California Wind Energy Association

Re: Comments on the DRECP July 2012 Stakeholder Meeting and Materials

This letter presents the comments of the California Wind Energy Association (“CalWEA”) on the Desert Renewable Energy Conservation Plan (“DRECP” or “Plan”) Alternatives and associated materials presented by the state and federal agencies comprising the Renewable Energy Action Team (“REAT Agency Team”) during the July 25-26, 2012, DRECP Stakeholders Meeting.

Map A. Proposed Wind Development Focus Areas (Wind-DFAs)

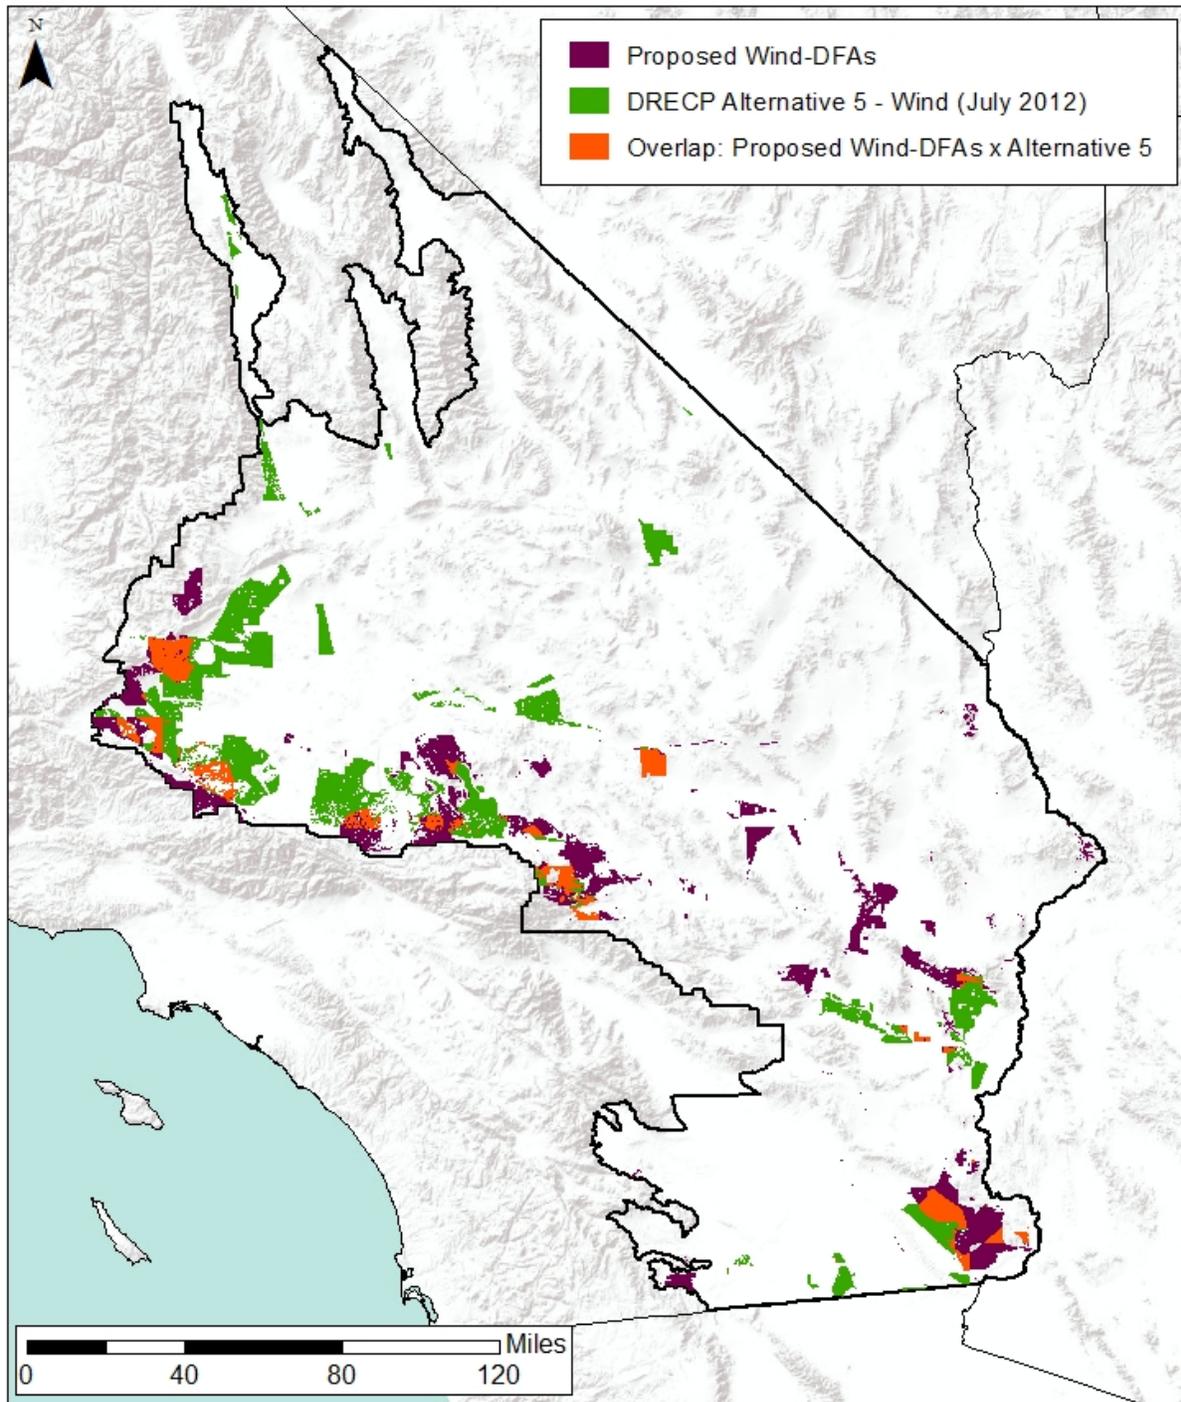
Map A, “Proposed Wind Development Focus Areas,” depicts the areas meeting these criteria, with two important exceptions:

- (1) The map does not screen for military red areas in certain areas where DoD did not provide DRECP Stakeholders with associated shape files.¹² When these shape files become available, additional areas will fall out of the proposed DFAs; and
- (2) The map does not screen out many urban areas where land-use restrictions and proximity to communities will likely prevent wind energy development (e.g., everything between West Lancaster and East Hesperia). These areas should be discussed with local governments and screened out from CalWEA’s proposed DFAs.

Map B. Overlap Between Proposed Wind Development Focus Areas (Wind-DFAs) and DRECP Alternative 5

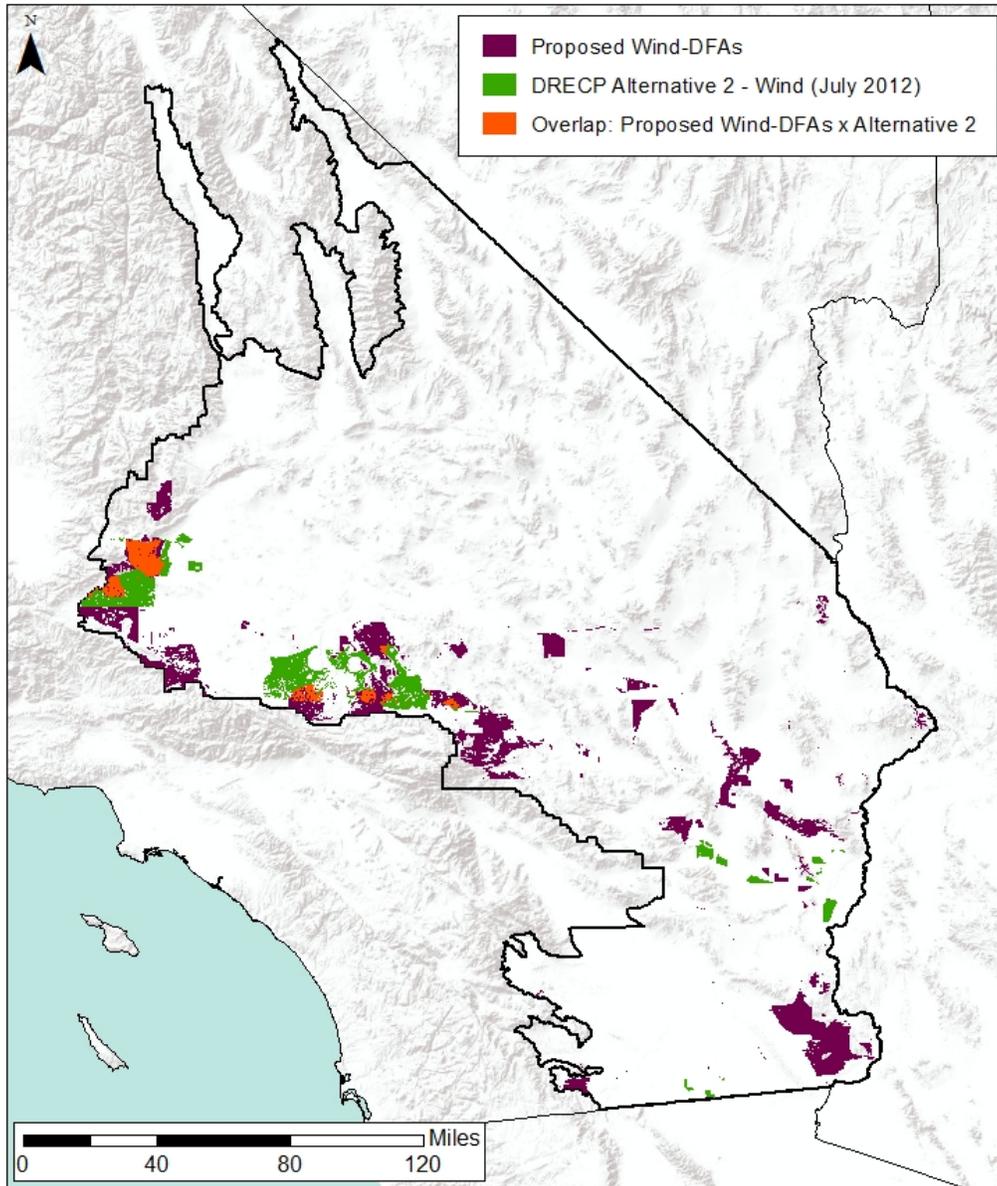
Map B shows the overlap between CalWEA’s proposed wind DFAs and Alternative 5 wind DFAs. As indicated, some areas within Alternative 5 do not meet the high-priority resource-area criteria and should be removed. Alternative 5 does not capture all high-quality resource areas that are unencumbered by any of the four known-conflict categories above, which were added. The overall total wind DFA acreage is largely unchanged (the total acreage in the Alternative 5 wind-DFAs was approximately 1.3 million acres; the total acreage in CalWEA’s proposed DFAs is slightly less, approximately 1.2 million acres). 29% of CalWEA’s DFAs is captured by Alternative 5.

Map D. CalWEA Proposed Wind-DFAs, Wind Evaluation Areas, and an Approximate Area Needed for 12,500 MW of Wind Generating Capacity
 California Wind Energy Association (CalWEA) - August 2012
DRAFT - Spatial data and maps were created and analyzed under time constraints and are subject to modification.

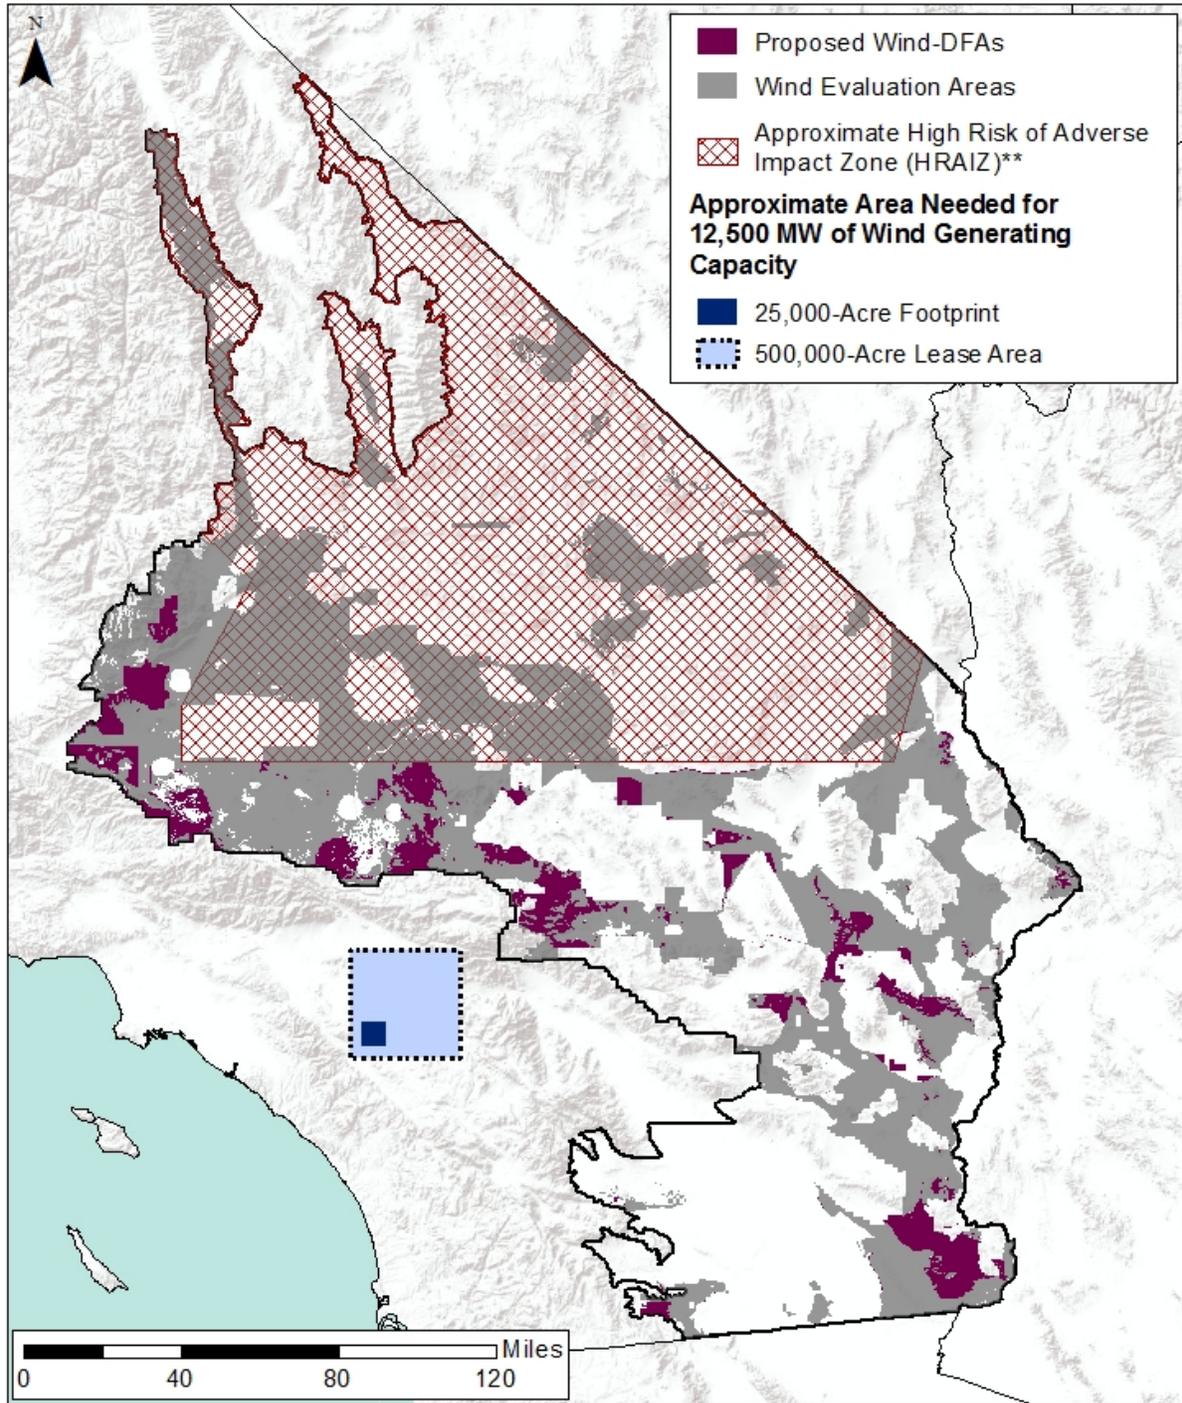
Map D depicts the cumulative total of these areas, which include:

- the known conflict areas described above (DoD high potential conflict areas, local government land-use zoning restrictions that currently preclude or discourage wind development, existing ACECs and DWMAs, and areas proposed to be set aside under the proposed "California Desert Protection Act of 2011"), and
- areas appearing to host 5-6 m/s wind speeds based on NREL/AWS TruePower maps, but which may later be proven to host higher-quality wind resources based on measurements conducted by wind energy development companies.¹³

The DoD's proposed HRAIZ area is shown in cross-hatch to indicate the very high hurdle that will face projects proposed in this area, making developments with commercially proven wind technologies generally very unlikely. There may, however, be some limited instances where the DoD may approve mitigated projects, or new technologies may be developed. In these cases, project applications in the evaluation areas should be processed. Nevertheless, it should be assumed that wind projects in the HRAIZ area will have significant development uncertainty; therefore, the DRECP should seek to prioritize wind development in other areas.

Overlap: Alternative 1 x HPWRA

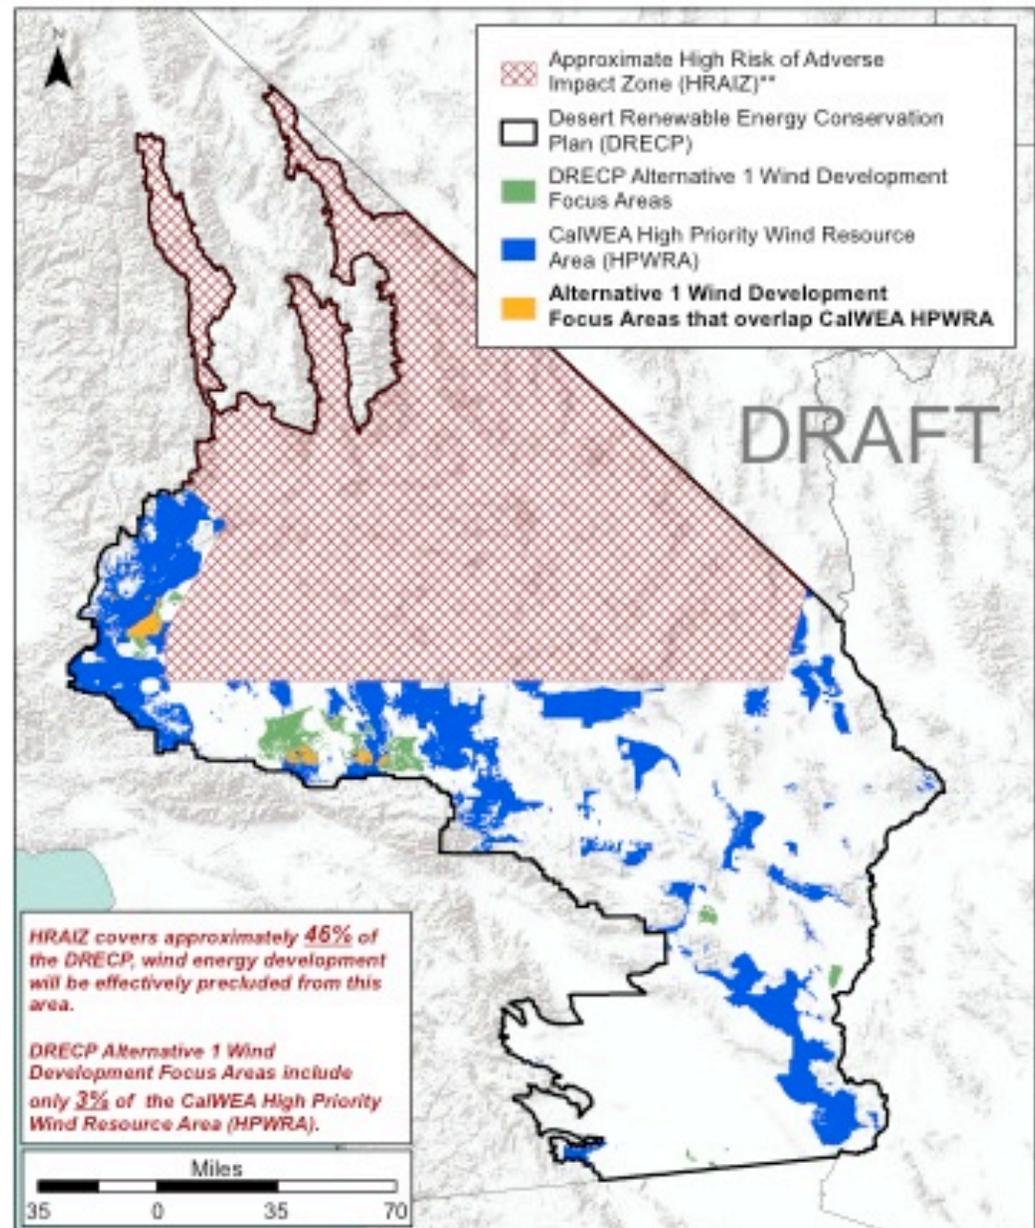
- ✦ HRAIZ covers approximately 46% of the DRECP, wind energy development effectively precluded from this area
- ✦ Alternative 1 Wind DFAs include only 3% of HPWRA

Overlap: Alternative 5 x HPWRA

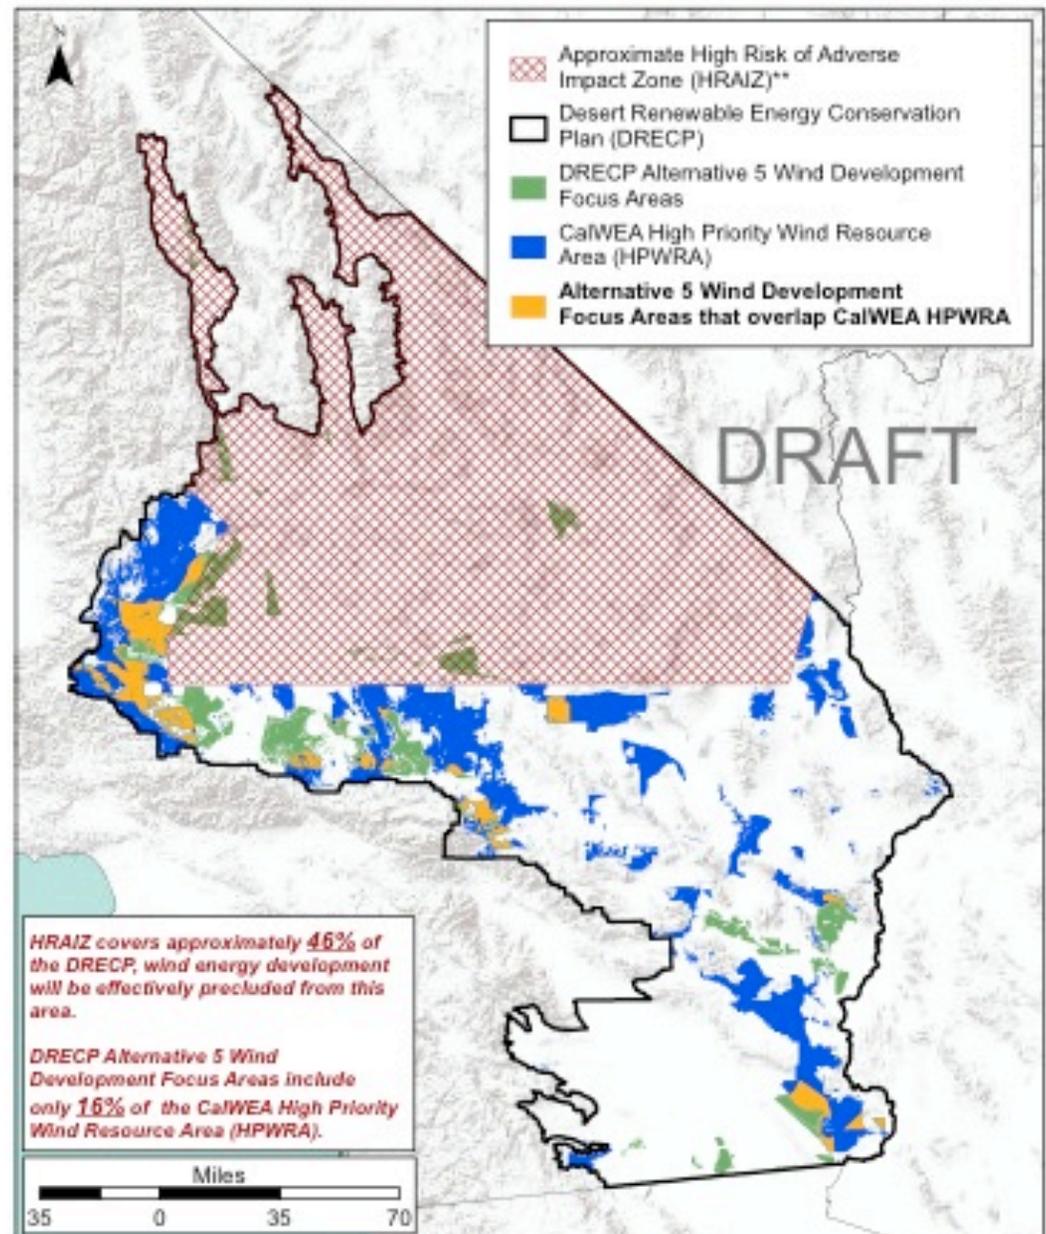
- ✦ HRAIZ covers approximately 46% of the DRECP, wind energy development effectively precluded from this area
- ✦ Alternative 5 Wind DFAs include only **16%** of HPWRA
